ADDENDUM #2

Project Name:
Newton Correctional IPI Homes for Iowa Phase II
A/E Project # 02401959.001
DAS# 9239.02 & 9239.03
RFB 923902-01
Addendum #2
Dated: August 20, 2025

Addendum Number: 002

Project Name: Newton CF IPI Homes for Iowa Phase II

M4.1A

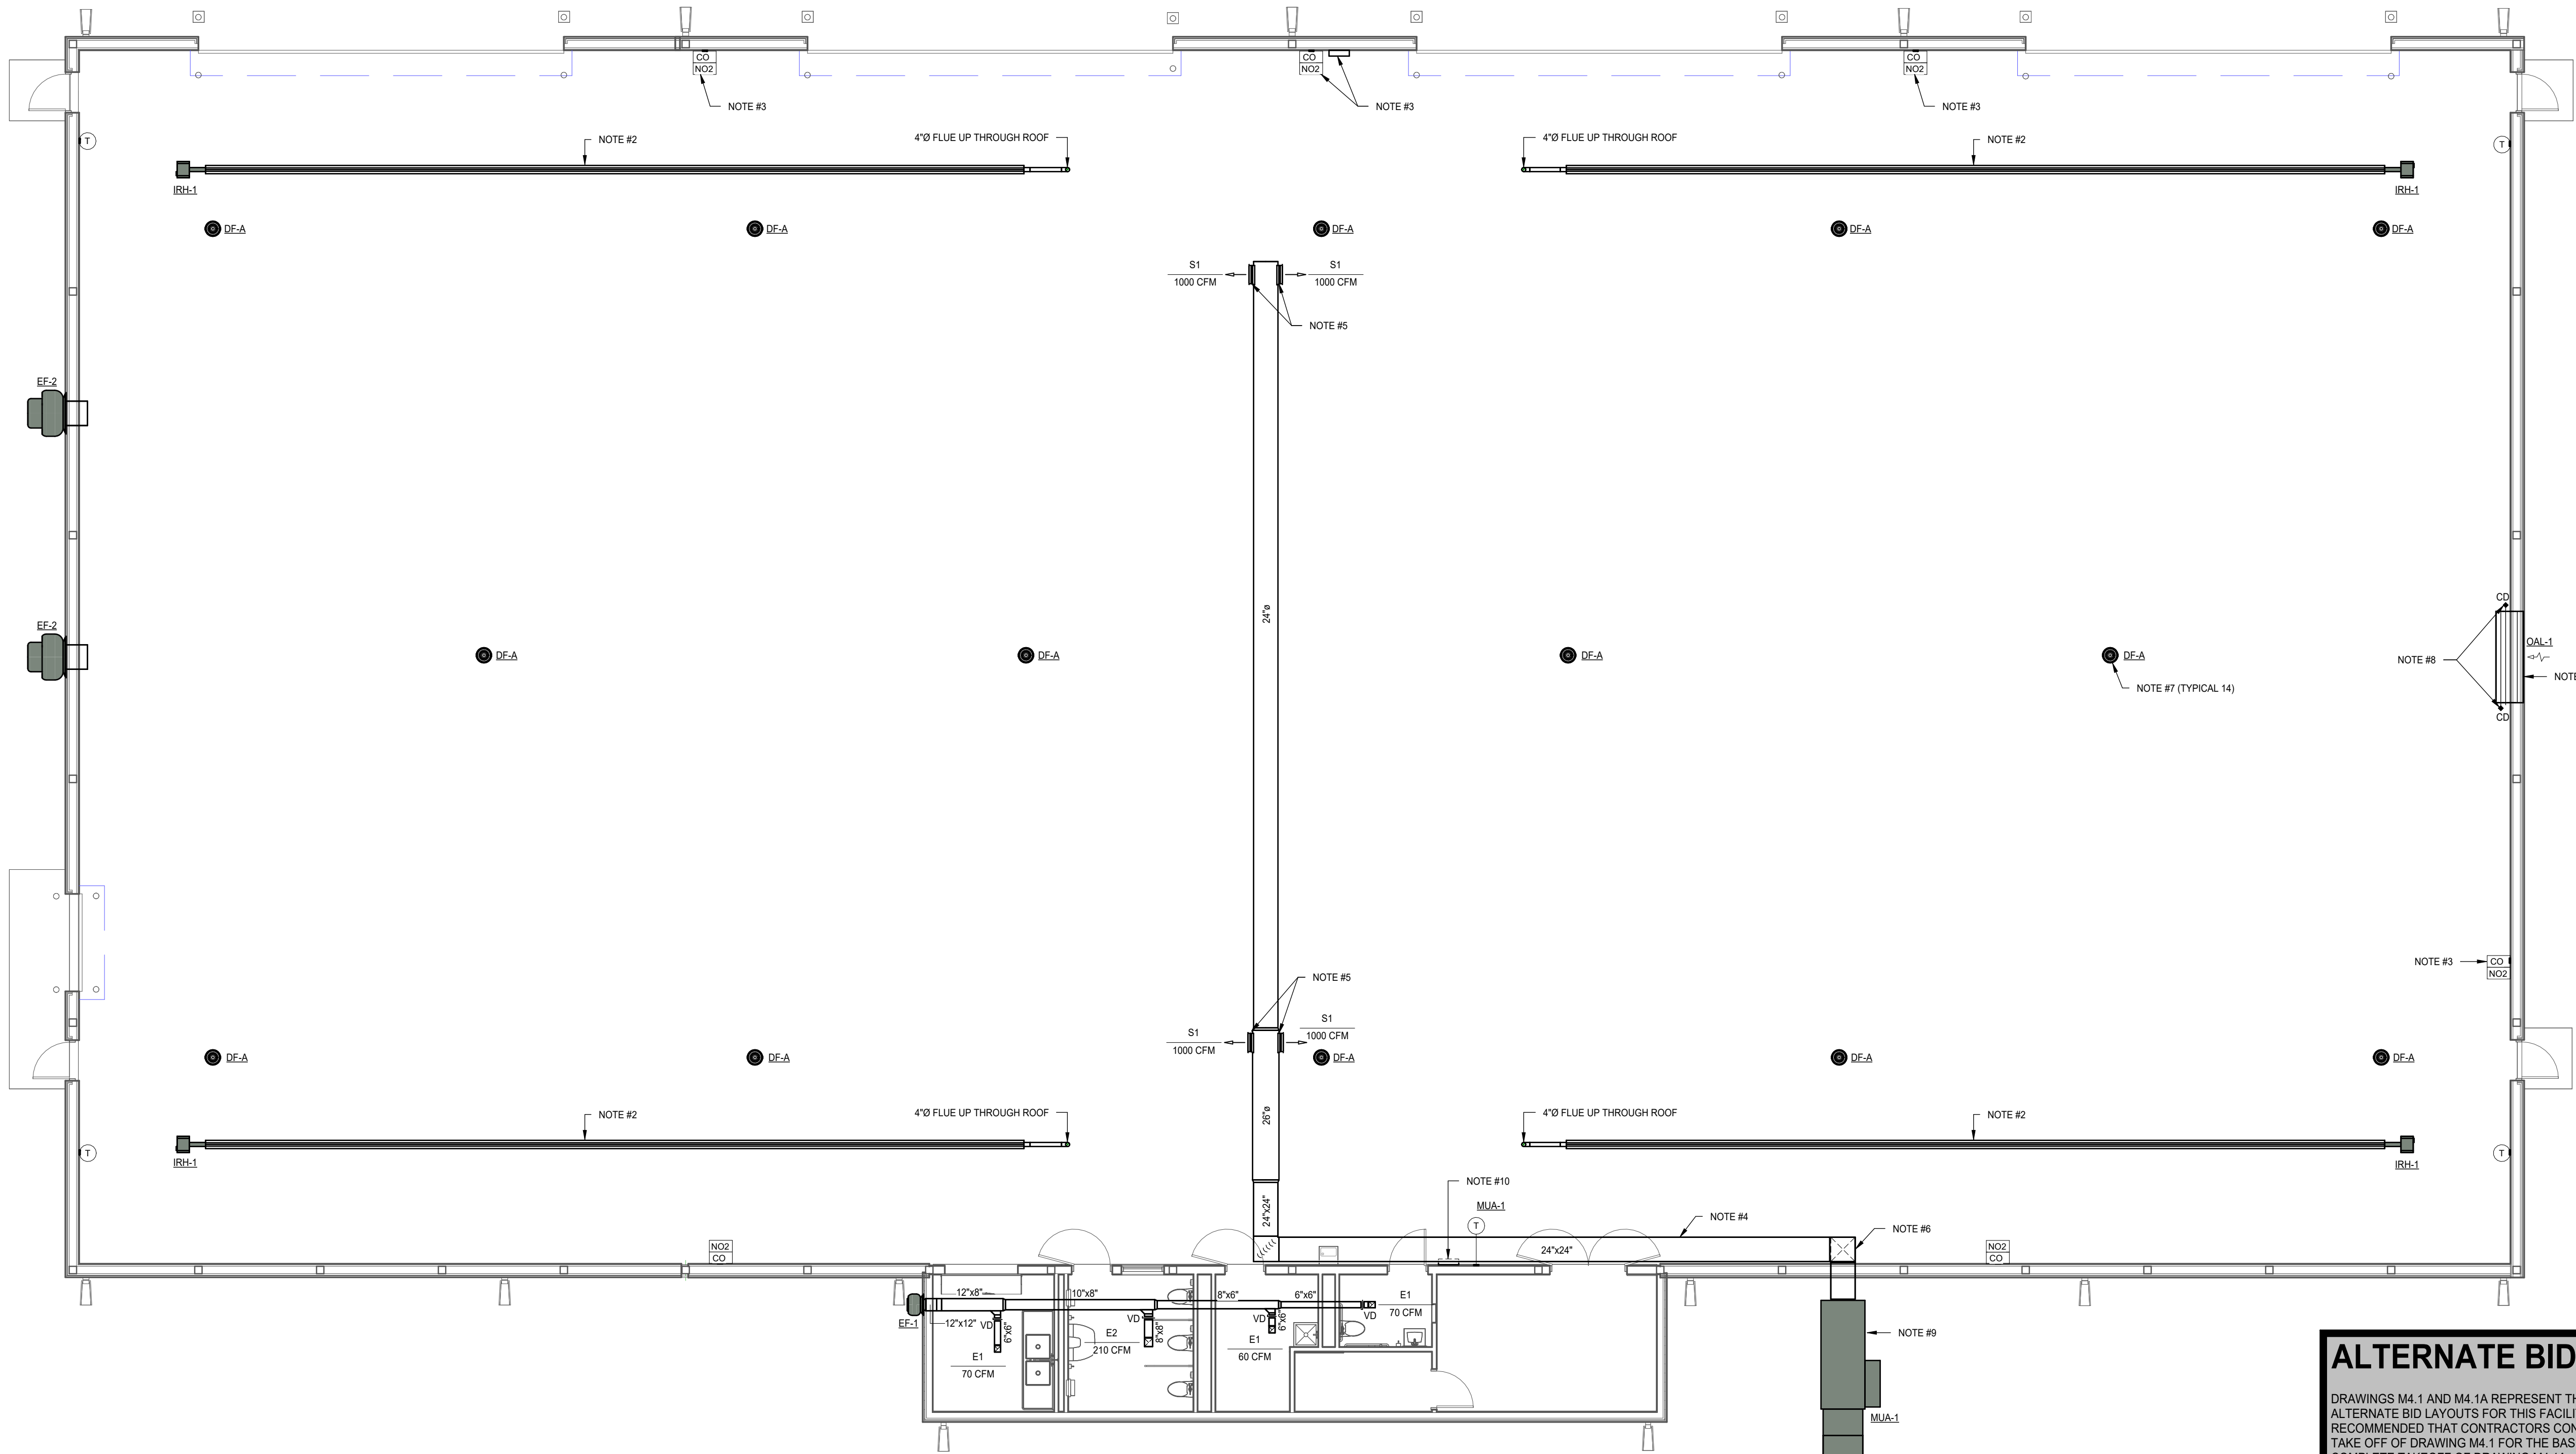
Revise Note #9.

Concrete mounting pad for mounting MUA-1 to be provided as part of Bid Package #1 General Construction. Selected MUA-1 manufacturer to provide necessary pad dimensions, specifications, etc. for the selected unit. Reference S1.1 for further details.
